Service Bulletin

Bulletin No.: 23-NA-178

Subject: Malfunction Indicator Lamp (MIL) Illuminated - Multiple DTCs Set

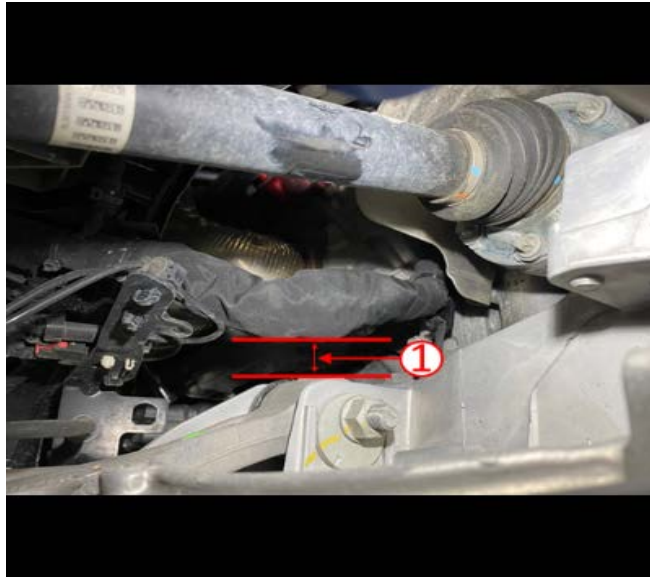
| Cause | <p>This condition may be caused by the engine wiring harness being built slightly out of position in its plastic channel by the supplier, resulting in a chaffing condition near the left rear lower control arm attachment.</p> |

1. Hoist vehicle and inspect the engine wiring harness for chaffing as indicated in the graphic above.
2. Repair the wires. Refer to *Wire to Wire Repair* in the Service Manual.

3. Remove the 9 tie straps holding the engine harness in the vertical channel and reposition the harness up as needed with at least 15 mm (1) of clearance to the control arm attachment point.
4. Replace tie straps and trim excess strap material.
